STATE OF CALIFORNIA
CALIFORNIA NATURAL RESOURCES AGENCY
DEPARTMENT OF WATER RESOURCES
DIVISION OF SAFETY OF DAMS

INSPECTION OF DAM AND RESERVOIR IN CERTIFIED STATUS

Name of Dam: Oroville | Dam No. 1-48 | County: Butte
Type of Dam: earthfill | Type of Spillway: Gated concrete weir and ungated conc. weir
Water is 122.2 feet below spillway crest and 143.2 feet below dam crest.
WS 778.8 ft
Weather Conditions: Sunny and warm
Contacts Made: Primary contacts – Paul Dunlap, Ryan Cooper, Vanesa Morones O&M HQ; Joe Eades, Scott Turnquist OFD
Reason for Inspection: Semi-annual inspection

Inspected by WPennington, Eric Holland, Austin Roundtree
Date of Inspection 8/22/16
Date of Report 9/27/16

3. The stable appearing downstream slope remains unchanged from recent inspections. The left gallery access is at left. The traditional seepage area along the left side of the dam was dried out due to the extended period of drought, double arrow.

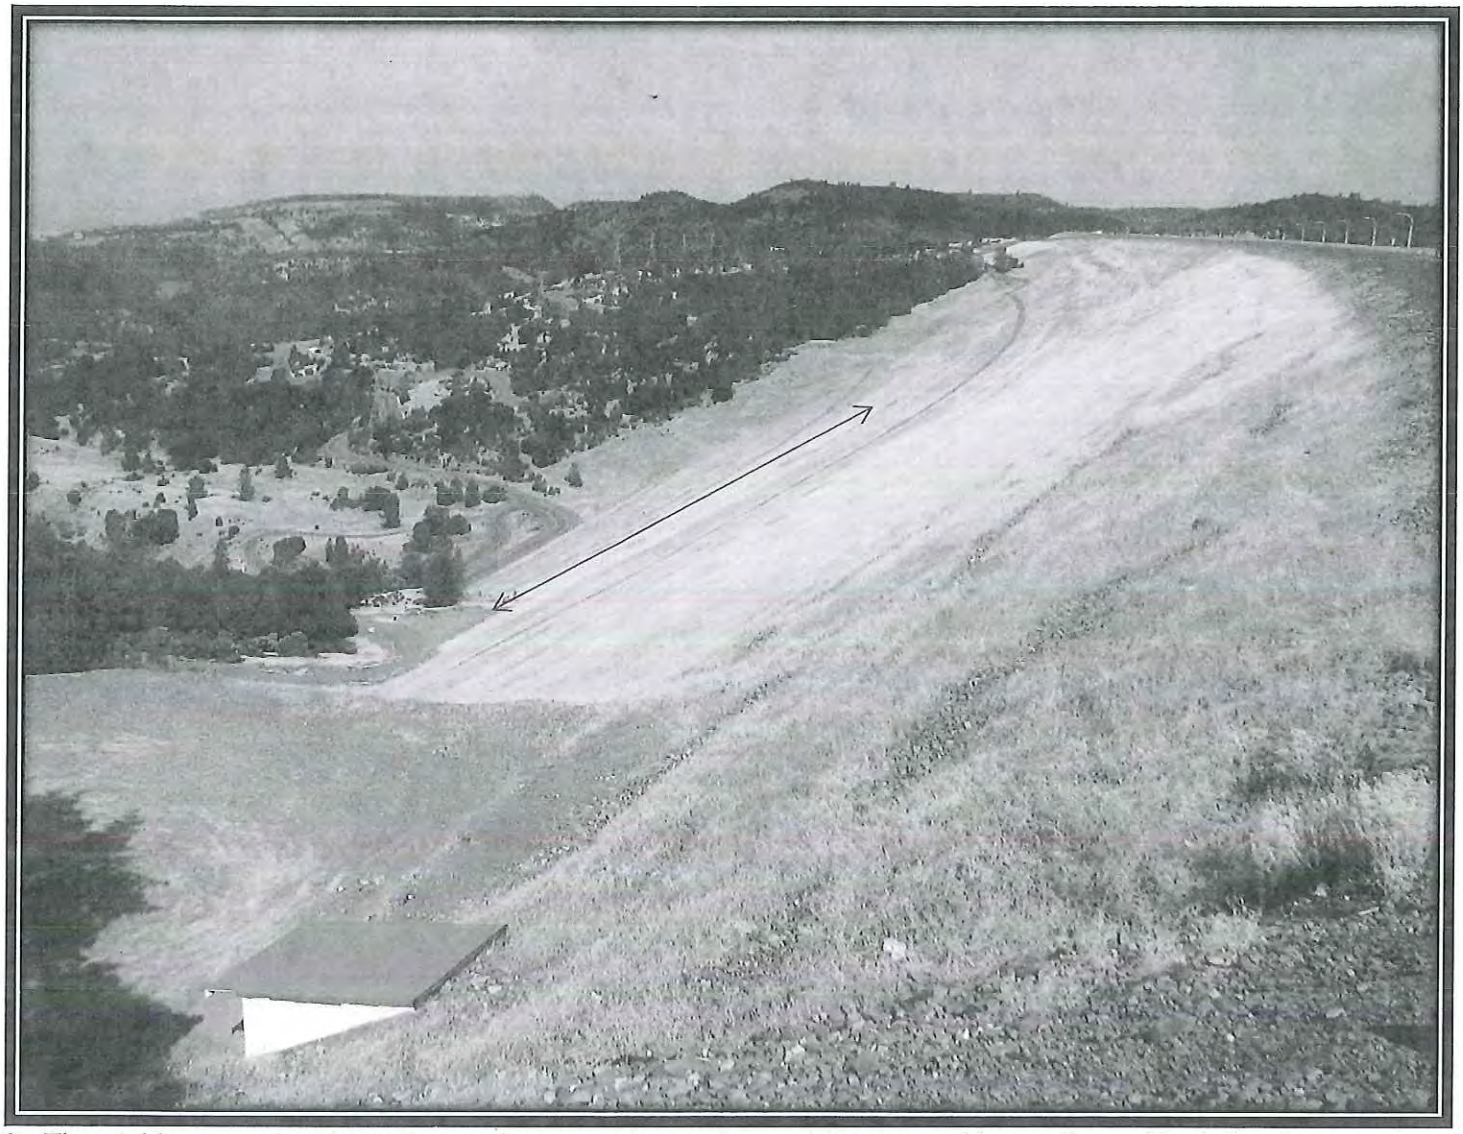
Dam	The crest road asphalt repairs have been delayed due to higher priority work. However, the roadway is satisfactory for use in the interim. The shoulder repairs remain in satisfactory condition, as well. The embankment, groins and abutments were viewed from the dam crest, the House T access bench, and the gallery access parking areas. See photographs 1 through 4. No evidence of embankment instability or other signs of excessive stress were observed. Vegetation and rodent control remain satisfactory. The rock along the upstream slope remains sound, except in a few areas where breakdown is occurring. No action is needed at this time. The surficial rock displacement along portions of the upstream slope appears to be related to wave wash. These areas should be monitored for excessive movement. The long standing damp area at mid-level on the left side of the dam has dried out due to the extended drought, photograph 3.

The traditional wet area at mid-slope on the left end of the dam was dry due to the drought conditions.

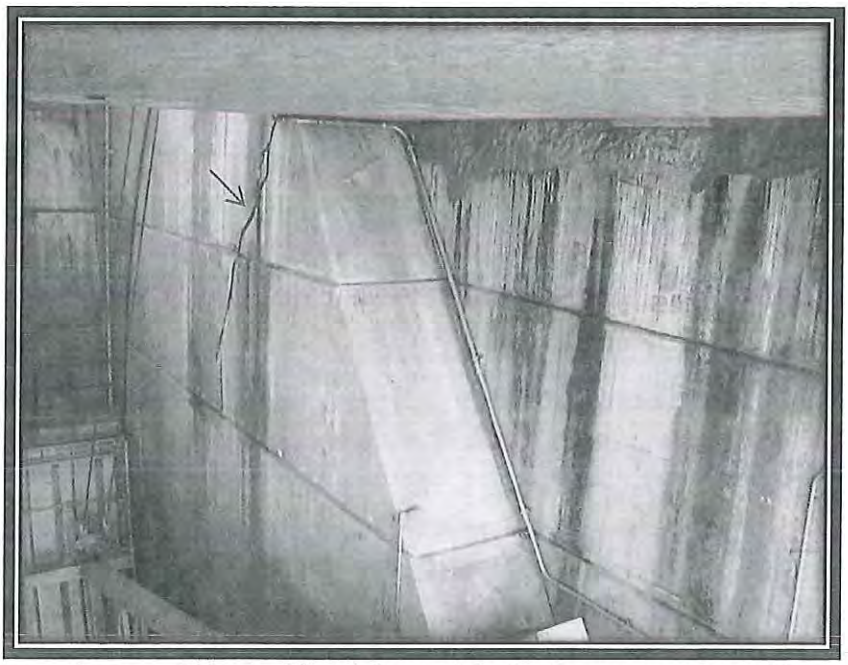
The spillway bridge appeared to be stable and in satisfactory condition, as well, photographs 12 and13. No new spalling was observed along the bridge bents, photograph 14, for example. The long standing diagonal crack on the left pier for gate 8 appears to have extended to the concrete chamfer below the old telltale paint mark, as evidenced by the length of the recently applied red telltale paint, photograph 14. An extension beyond the chamfer would warrant an investigation into the cause.

14. This view is looking upstream within the Flood Control Outlet Structure. Gate 8 is at left. Spalling at the left bridge bent remains dormant, as evidenced by the unbroken paint at the far right. The same is true of the opposite abutment. The marked crack, arrow, has extended downward to the lift line over a long period of time. It will likely stop at this location. If not, the conditions should be evaluated.

21. This view is looking upstream at the center pier of the Flood Control Outlet. The top deck is visible. A crack was recently noted at the location shown, and is also shown in photograph 22.

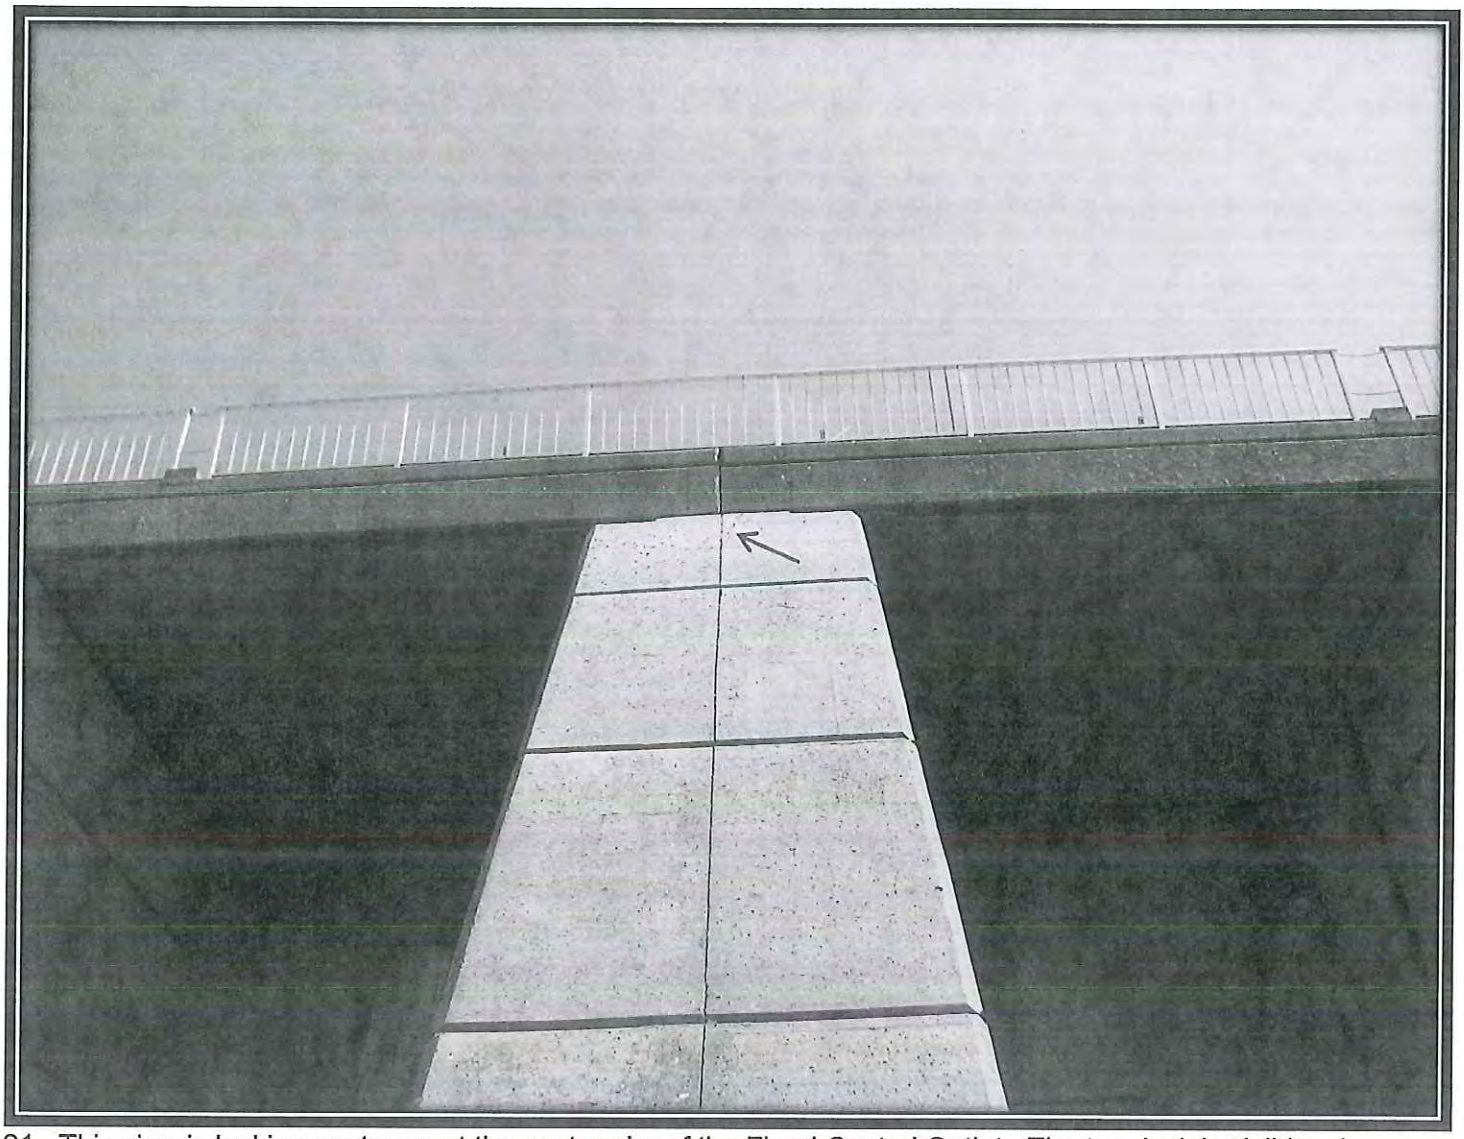
While on the upper deck of the Flood Control Outlet, Paul Dunlap pointed out a crack at the top of the center pier, photographs 21 and 22. This feature is adjacent to the transverse construction joint that separates the two halves of the Flood Control Outlet. The speculation is that the crack resulted from the 1975 Oroville Earthquake. Possible related concrete damage was found on the hoist deck floor, where the construction joint crosses a walk through opening at the back of the center pier, photograph 23. Broken concrete adjacent to the construction joint is also visible from the trunnion deck when looking up at the landing for the hoist deck above, photograph 24. Another indication of movement is discernable as a slight vertical bow on the top of the hoist deck hand rail above the construction joint. None of the observed concrete damage poses a dam safety concern, and may not be linked to a single event. This information is being provided for the record.
